## Product Change Notification / SYST-10NIVQ377

ERRATA - ATtiny202/402 Silicon Errata and Data Sheet Clarification

## ATtiny202/402 Silicon Errata and Data Sheet Clarification

**Figure 3-1. Block Diagram**

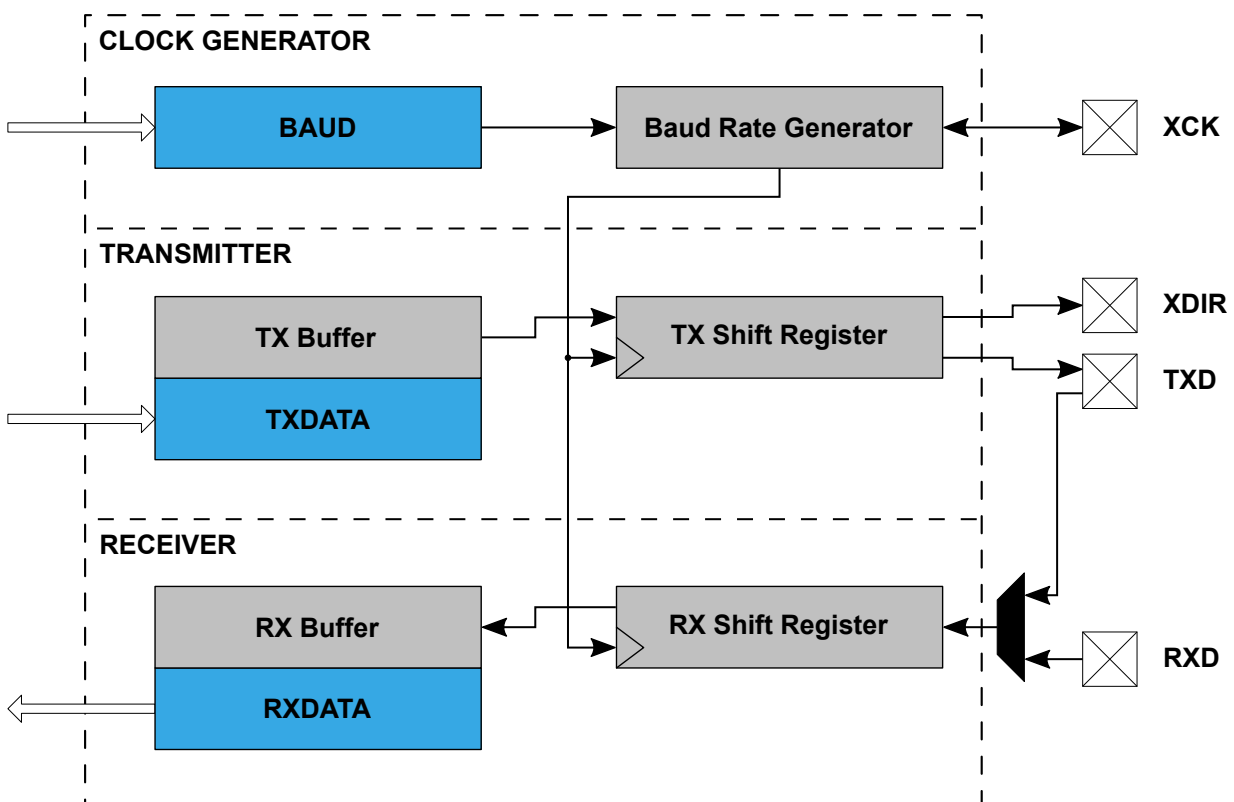
The block diagram is missing that USART TX is double-buffered from figure 25-1 in the data sheet. Added **TX Buffer** is shown below.

The transmitter consists of a **two-level** write buffer.

The data transmission is initiated by loading the **Transmit Data (USARTn.TXDATAL and USARTn.TXDATAH)** registers with the data to be sent. The data in the **Transmit Data registers are moved to the TX Buffer** once it is empty and onwards to the Shift register once it is empty and ready to send a new frame.
